DEVELOPMENT REVIEW BOARD REPORT

CASE NUMBER/ PROJECT NAME	McDowell Mountain Ranch Park & Aquatic Center 77-DR-1994#2		
LOCATION	SEC Thompson Peak Parkway & McDowell Mountain Ranch Road		
REQUEST	Request site plan and elevations approval for a park and aquatic center.		
OWNER	City of Scottsdale 27626		
ARCHITECT/ DESIGNER	Weddle Gilmore Architects (480) - 517-5055	APPLICANT/ COORDINATOR	Alison Tymkiw City of Scottsdale 480-312-7985

SITE PLAN
1" = 60'

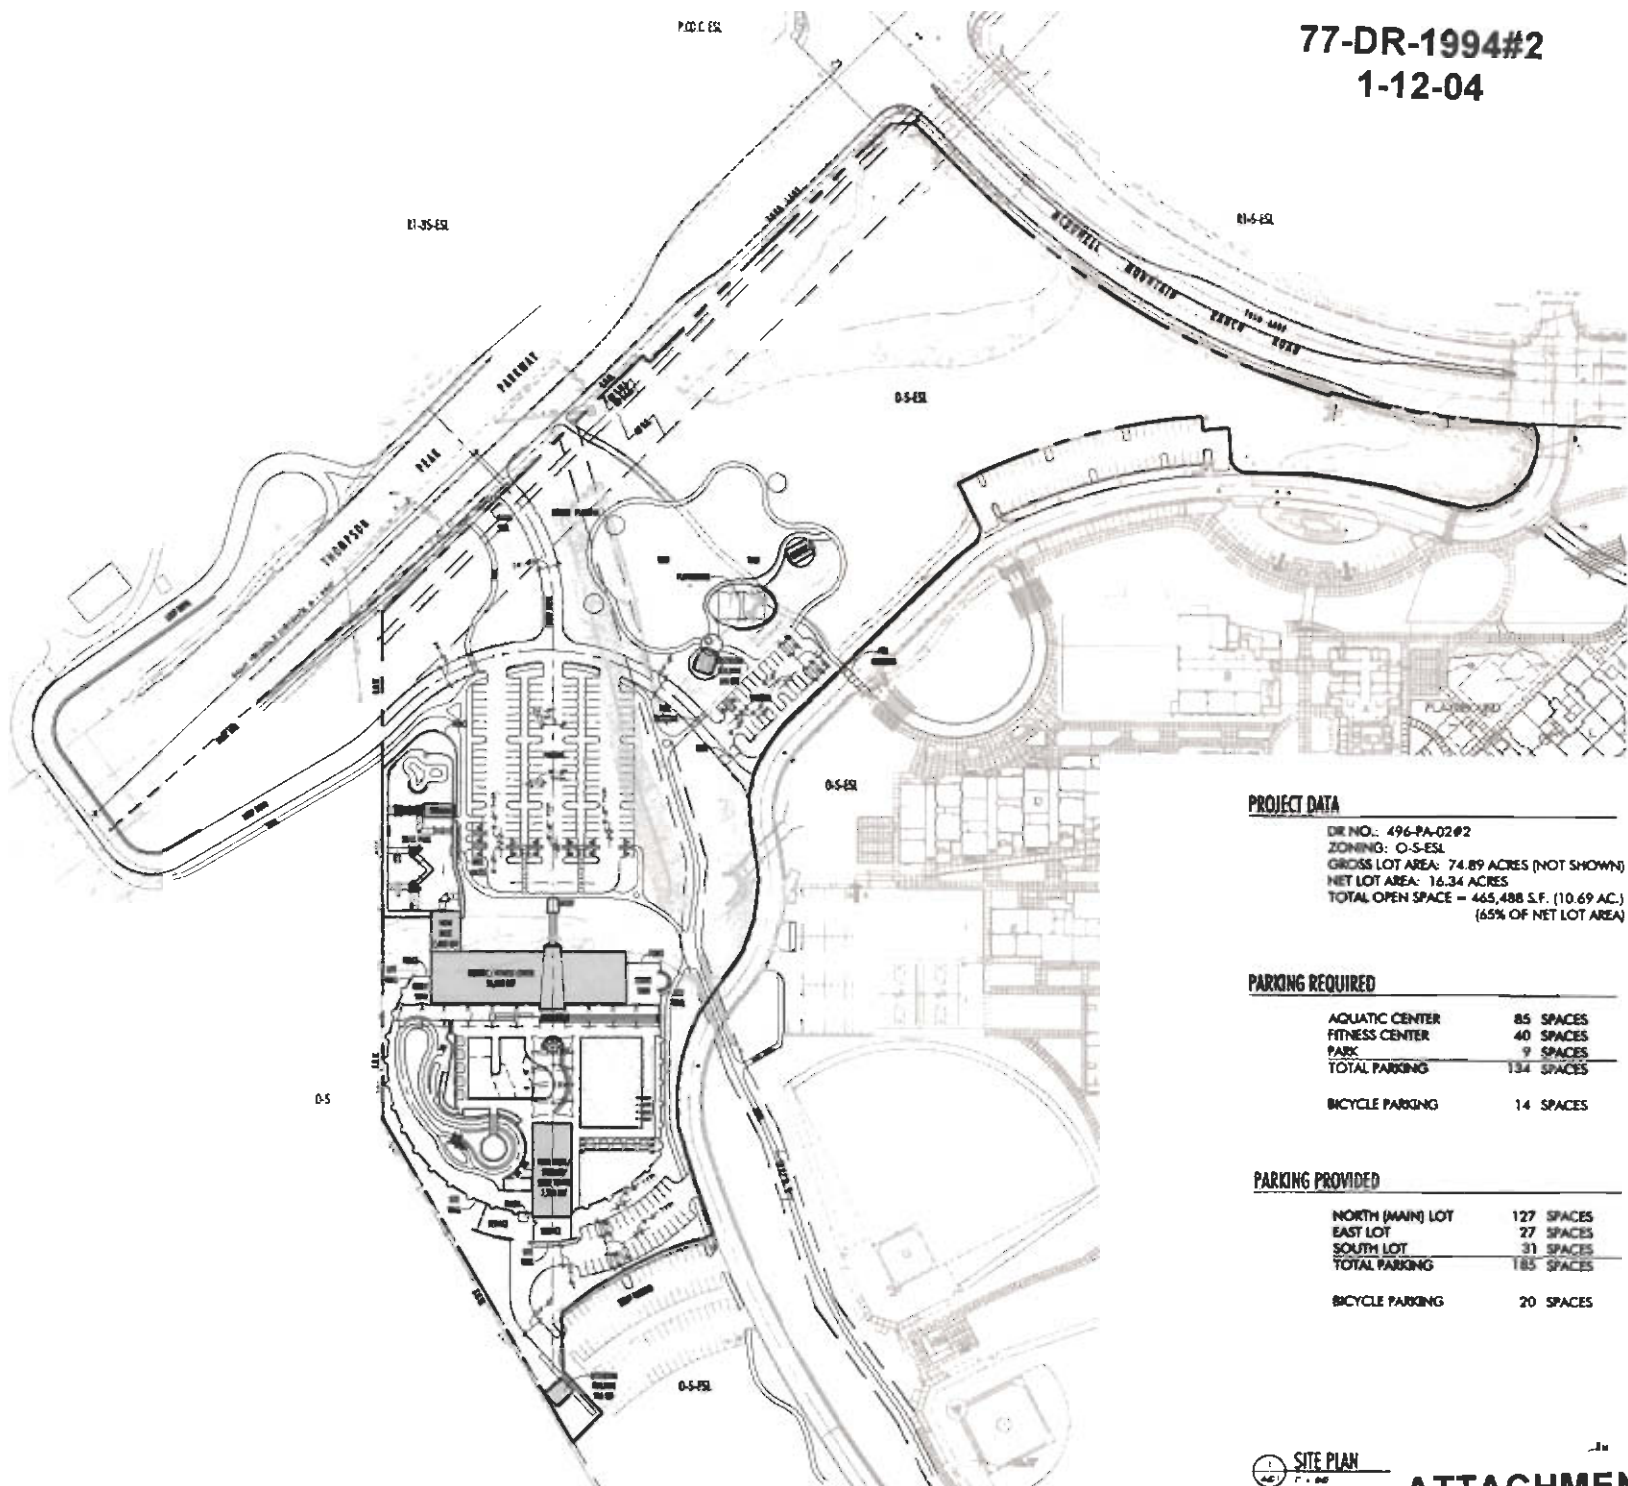
- (i) A new trail located at approximately 170 feet west of the proposed Entry Drive, linking Thompson Peak Parkway to the proposed Loop Drive to the south at a 90 degrees angle (the proposed location of this trail, as shown on the preliminary architectural site plan, dated 1-12-2004, is not acceptable).

The proposed refuse enclosure, as shown on the preliminary architectural site plan, dated 1-12-04, is not acceptable. The proposed enclosure should be relocated approximately 70 feet to south of the proposed location and positioned in such a way that it would face the incoming refuse truck from east.
